NOTICE TO PROCEED

Project: Grand Junction Fire Department Fire Station #3 Construction
IFB-4889-21-DH

Project:
Grand Junction Fire Department
Fire Station #3
GMP Estimate

C2-0

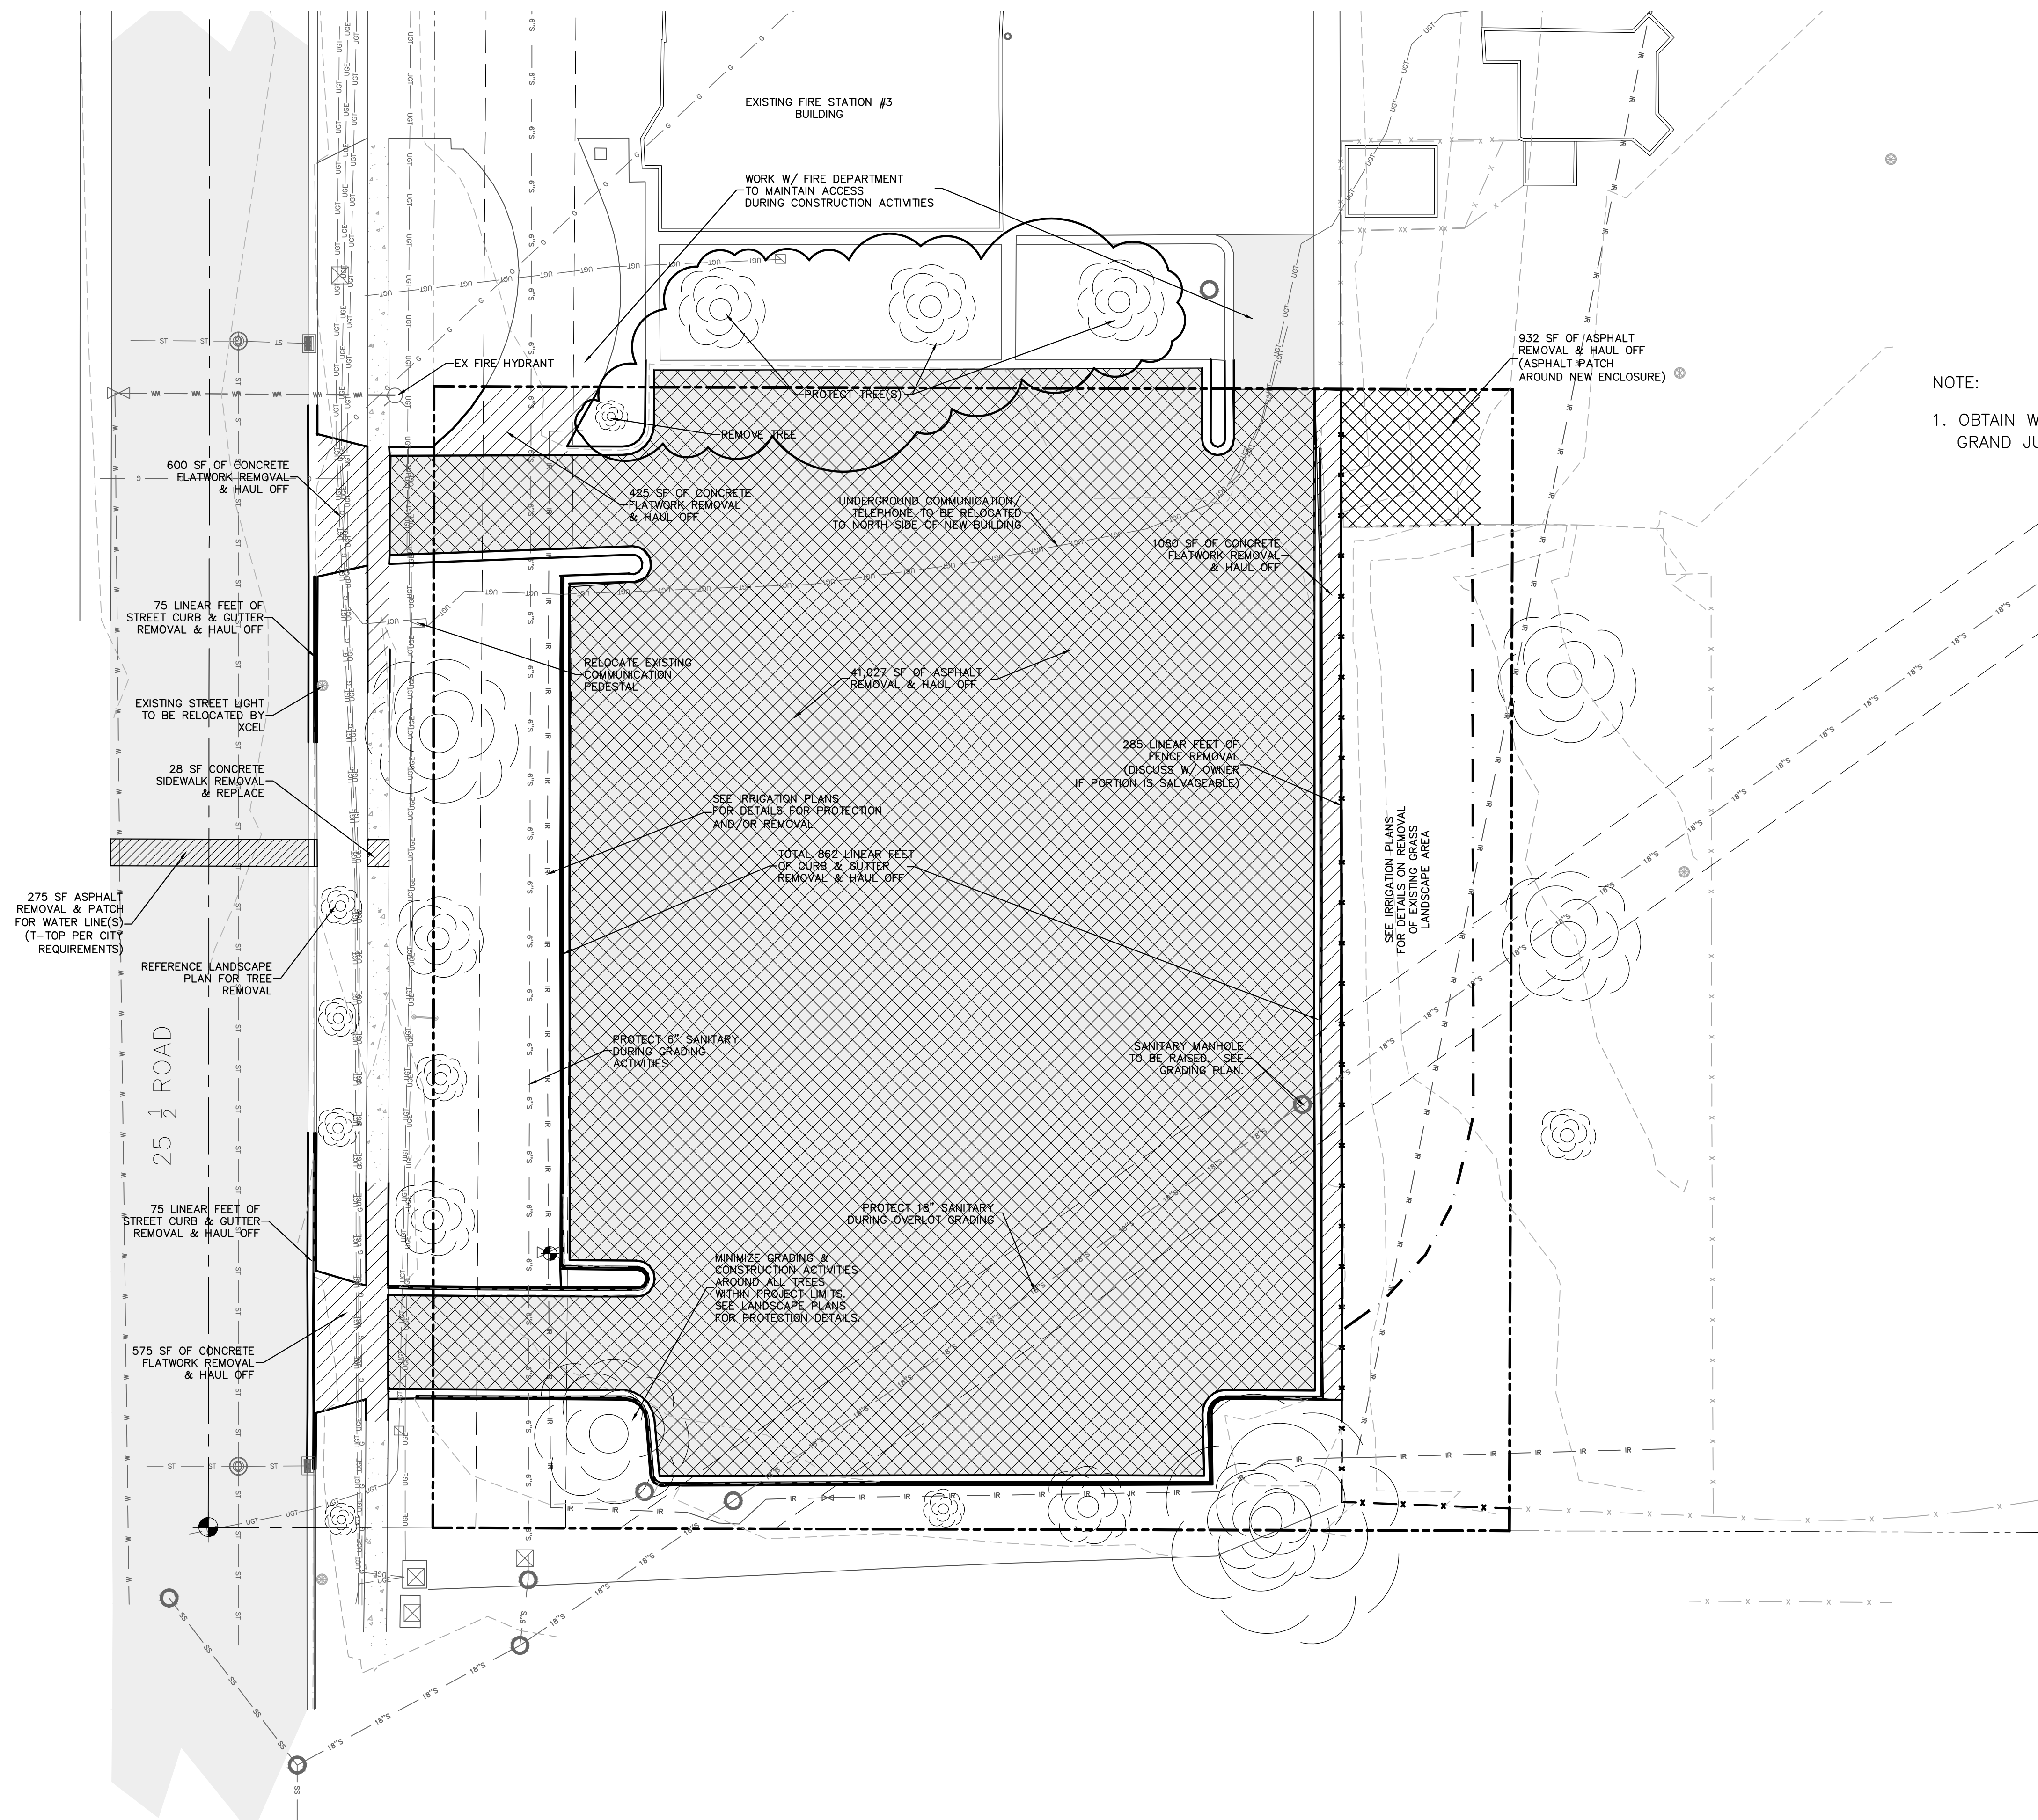
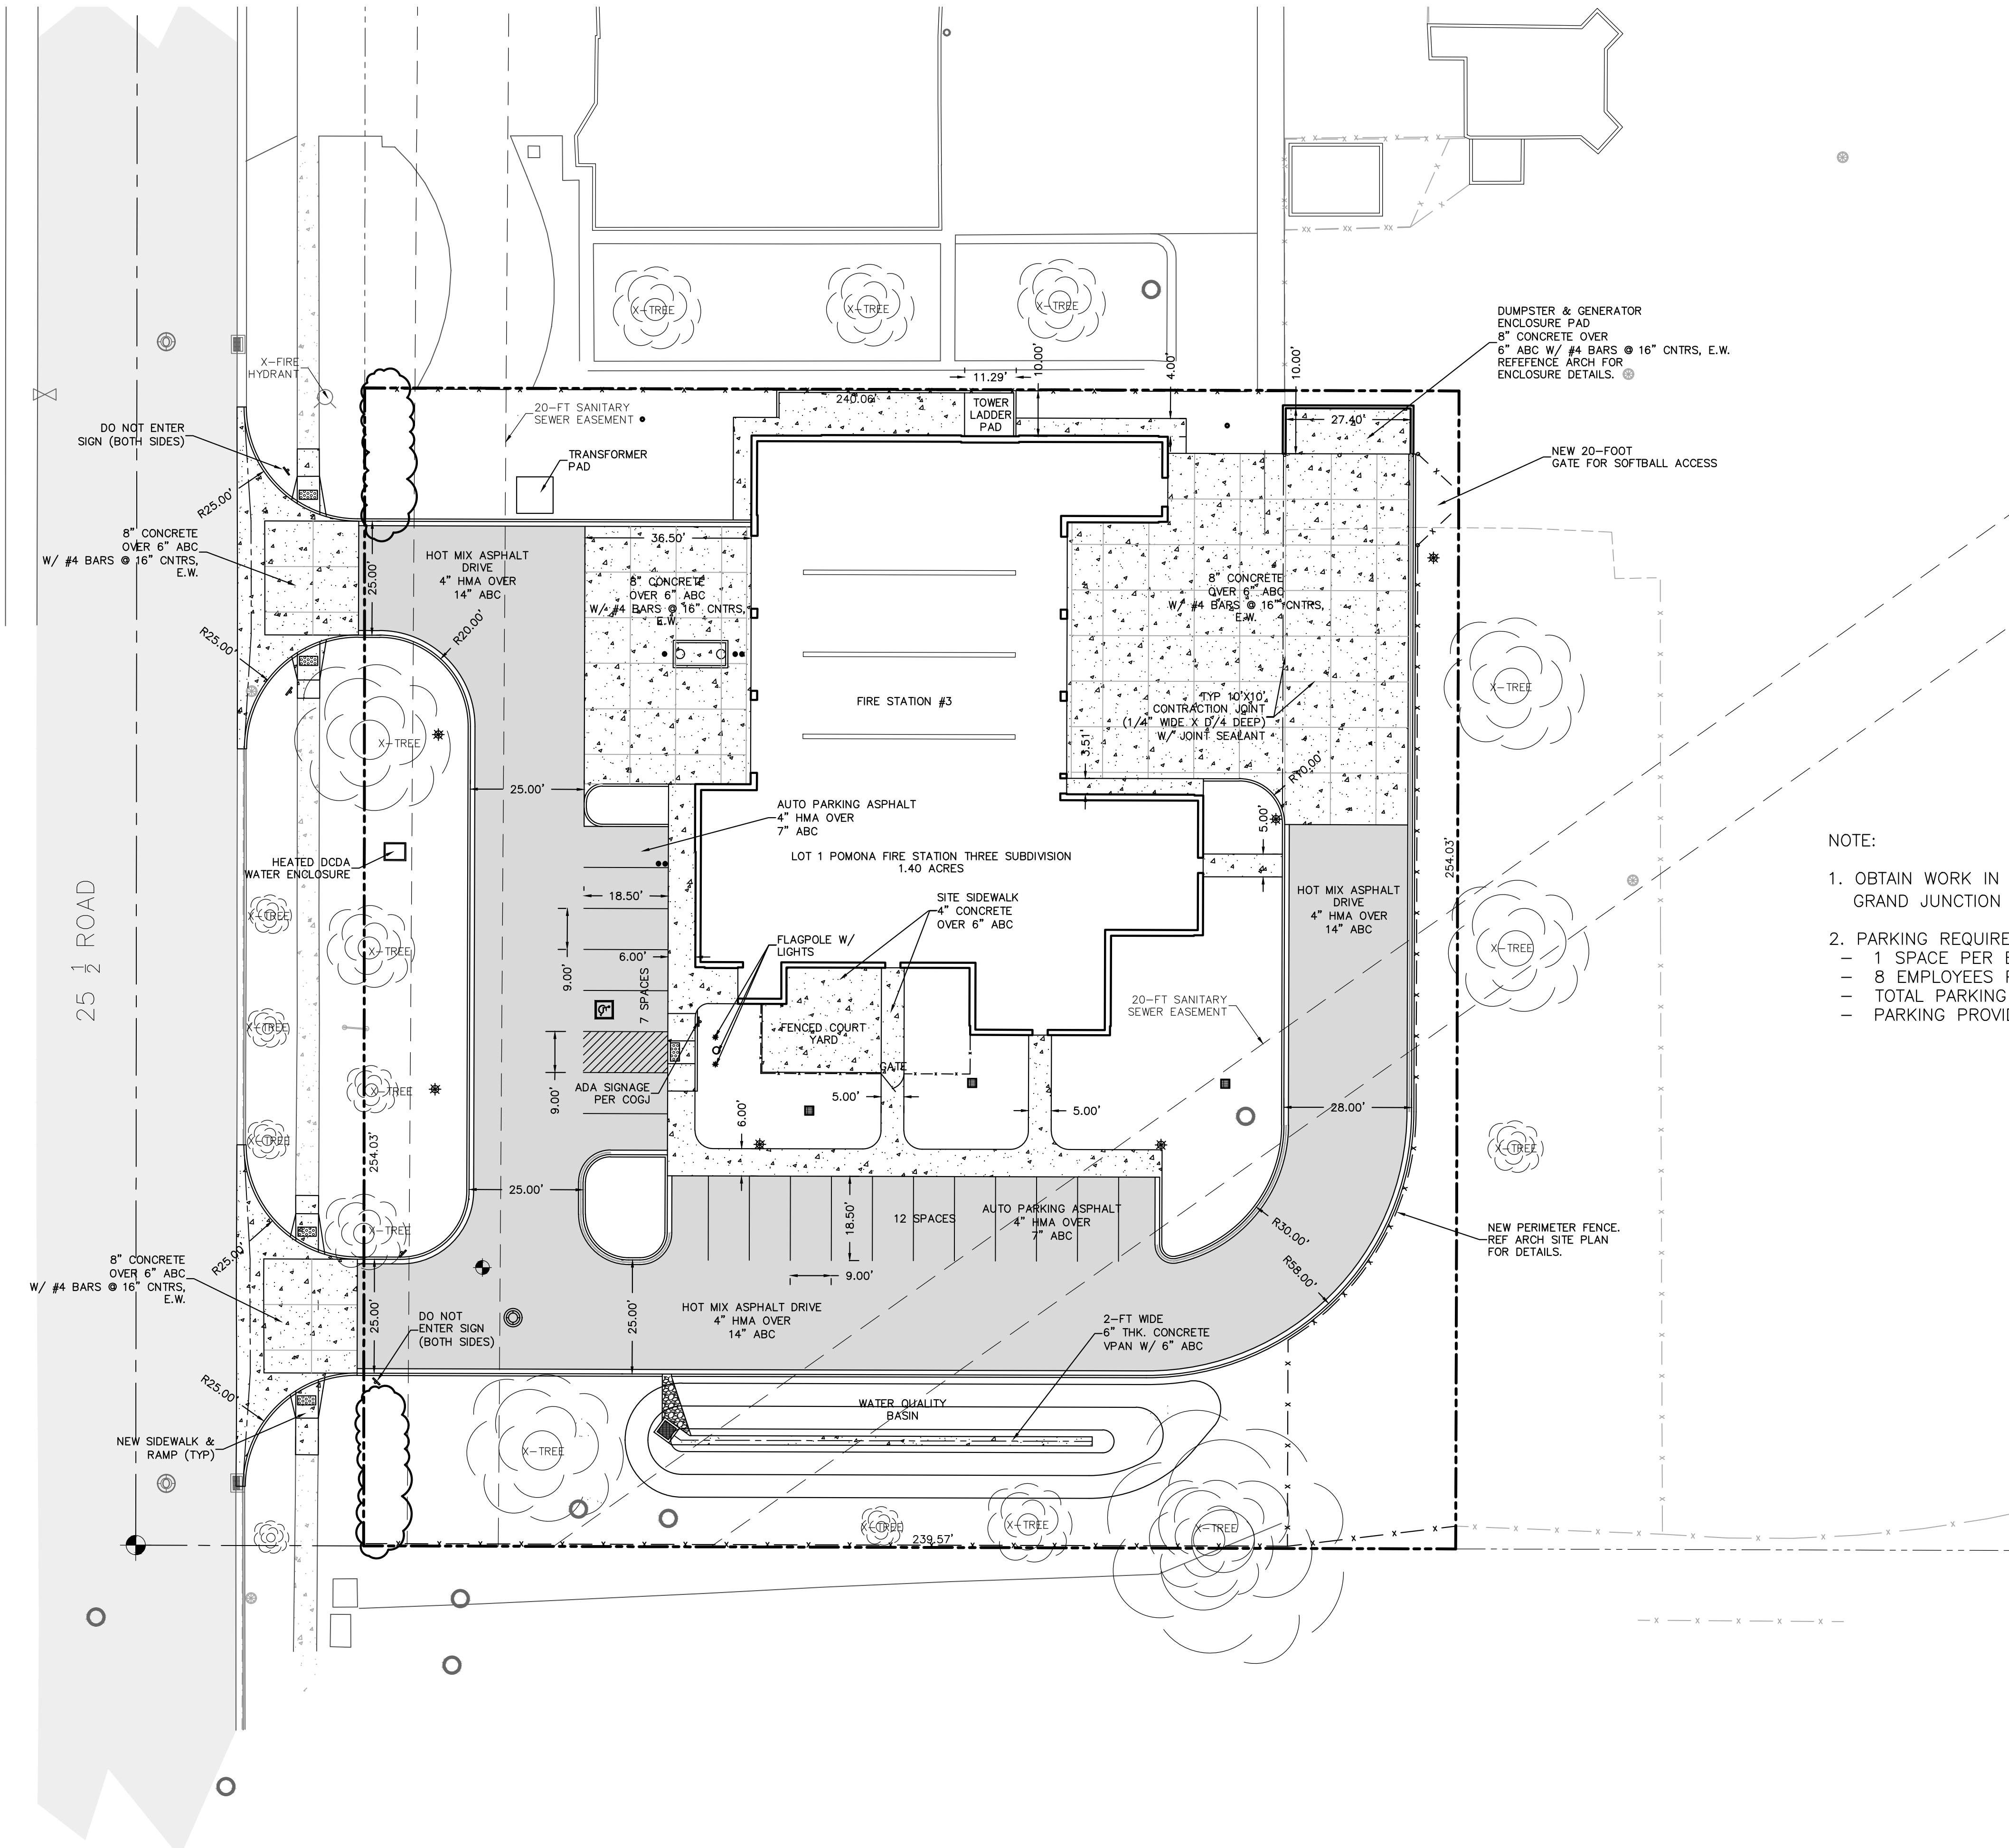
- A. The existing trees along the south side of the existing fire station shall be protected, as well as any existing utilities in this area. Contractor may demo some landscaping north of the existing parking - contractor to coordinate irrigation shutoff with GJ Parks. Successful bidder shall coordinate with Owner for extent of required demolition and protection of existing trees. Refer to updated sheet C2-0.
